**RE: Winterbourne Wind Farm Environmental Impact Statement (SSD-10471)**

Enclosure: Attachment 1 Detailed BCD and NPWS Comments – Winterbourne Wind Farm EIS

## **Attachment 1: Detailed BCD and NPWS Comments – Winterbourne Wind Farm EIS**

**Figure 1: Site location B006, B007, and B176 inspected by the BCD on 7 December 2022 - further avoid should be considered for the proposed infrastructure of the wind turbine locations and the access track - the pink mapped areas are CEEC and SAI entities.**

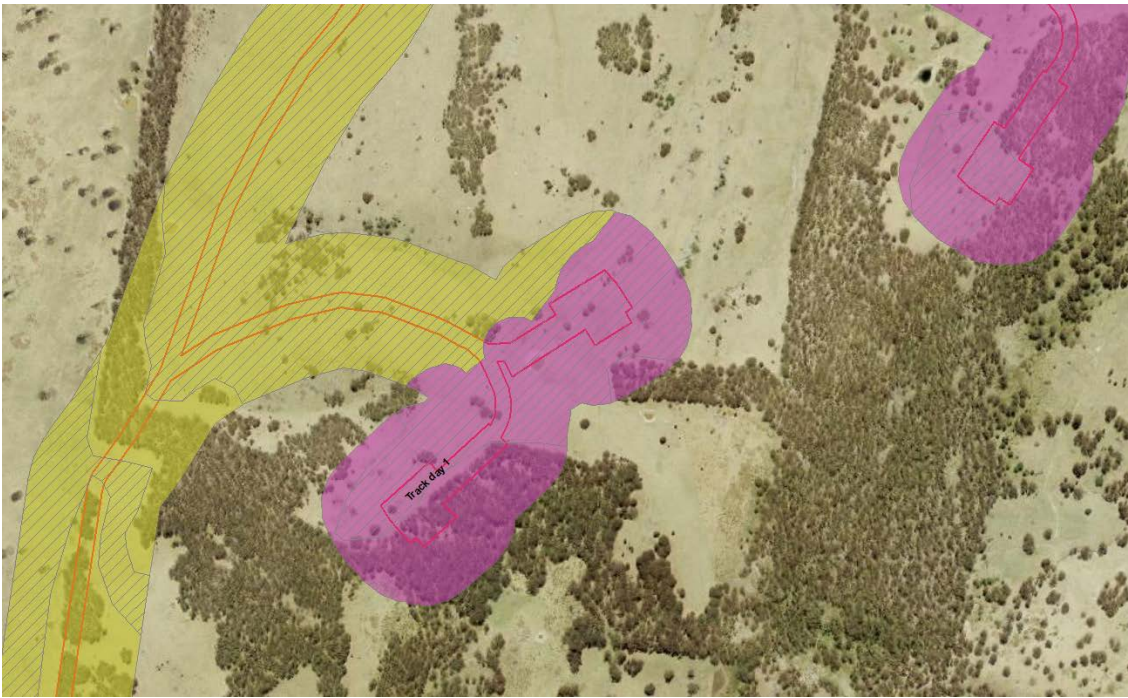
Some example areas where further avoid and minimise could be considered are provided in Figures 1, 2 and 3 below.
